NAFLIC - Standards & Related Documents Committee | TECHNICAL BULLETIN

Moser's Rides Spring Ride service bulletin

SPRING RIDE BULLETIN

FOR SPRNG TOWER MODELS WITH RELEASE BAR GAS SPRING RETURN

(See Fig 1 part 1)

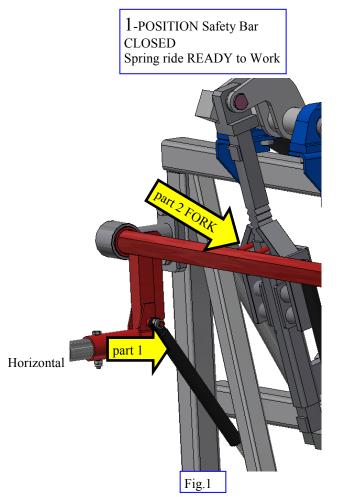
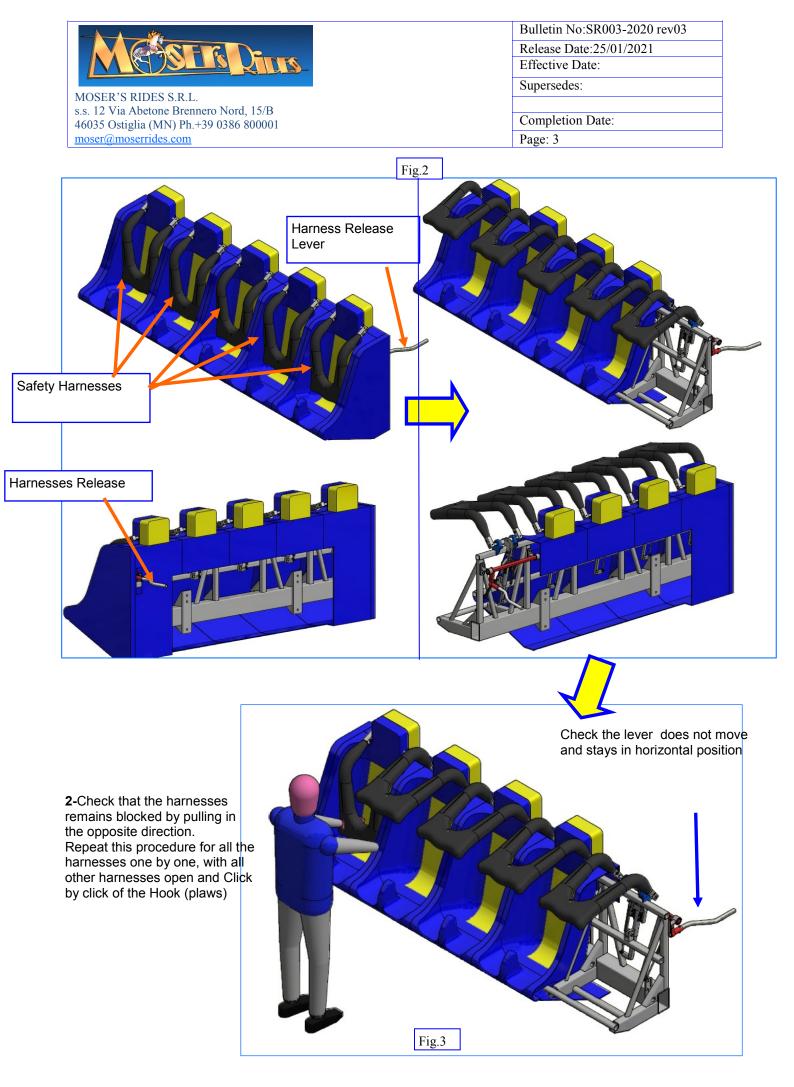
EVERY DAY Check the gas spring that is able to keep the collective release lever in this position without yielding, the release handle is in the fully risen position with the gas spring extended. If necessary replace it with an identical gas spring that has a minimum force of 350N.

EVERY YEAR Replace this gas spring. (see Fig 1 part 1)

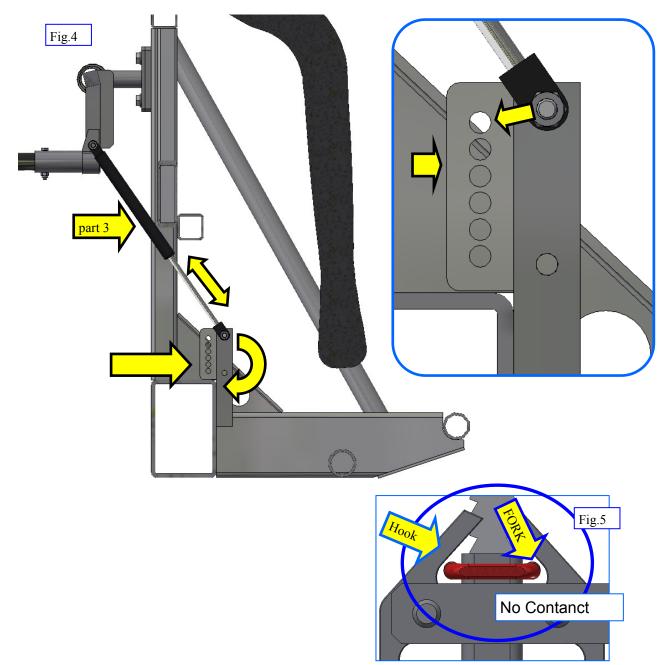
EVERY WEEK Check with the harness release lever in the rest position, that the forks (red) are not in contact with the pawls, space must remain. (Fig 5) Check the correct position of the harness release lever gas spring with the correct position of forks and hooks as shown in the figure. (Fig 4 part 3 & Fig 5)

MAINTENANCE During replacement, check for the proper size of the harness release lever gas ram, and after replacement that no interference/contact between the fork and hook exists (Fig 5).

600N 350N 37 36 35 34 33 32 31 23 53 27 26 25 24 23 23 2

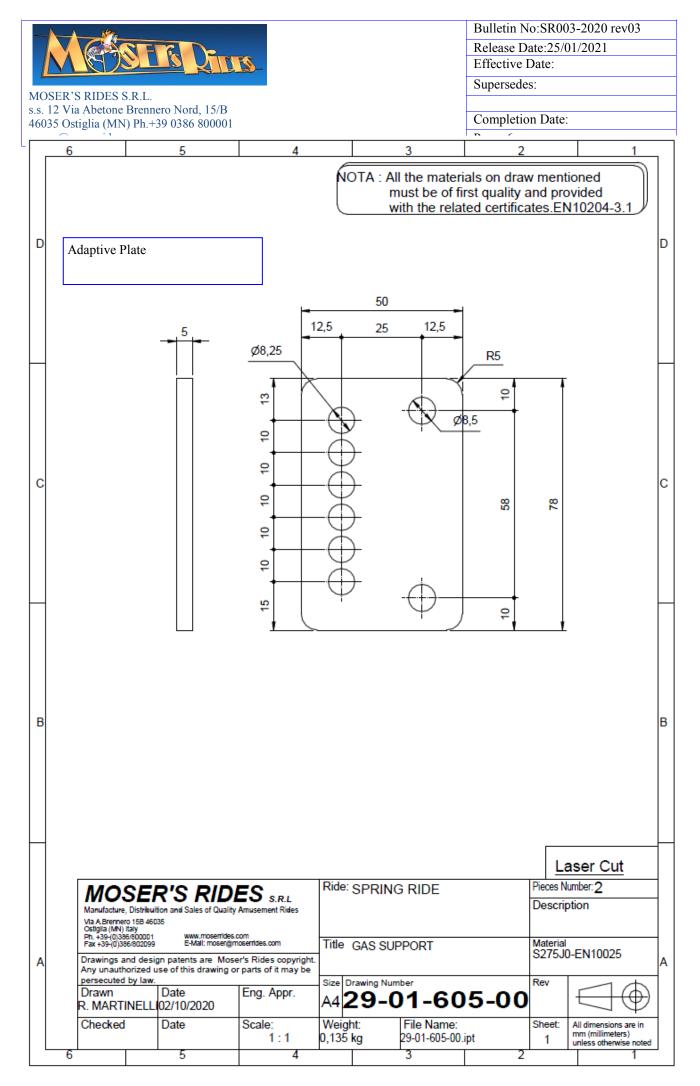
The length of the Harness Release lever Gas Spring Shall can be 385 mm eye to eye (N350). Or 365mm with the adaptive plate.

The length of the Harness Release Gas Spring shall be 365 mm eye to eye (N600).

If tolerances of gas ram manufacture cause install problems it can be installed an adaptive plate. (see instruction in the next page & fig 4 insert) with fastener.

5- SECONDARY DEVICE

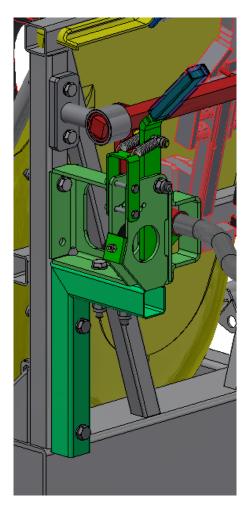
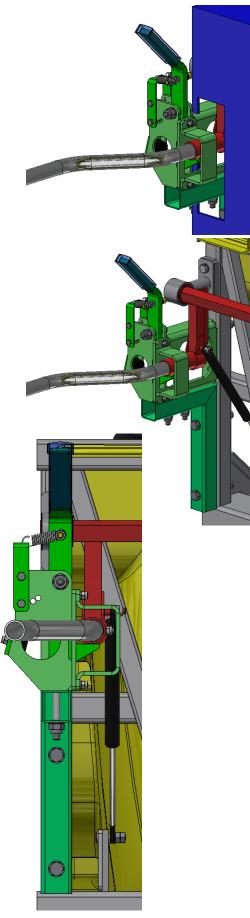
To improve the safety, a spring loaded secondary device to the restraint release lever can be installed. Example images attatched.

This spring loaded secondary device application can be provided by Moser Rides with instructions for site instilation by maintenace teams.

Note the attached sketches are showing the concept and <u>should not</u> be taken as techncial drawings.
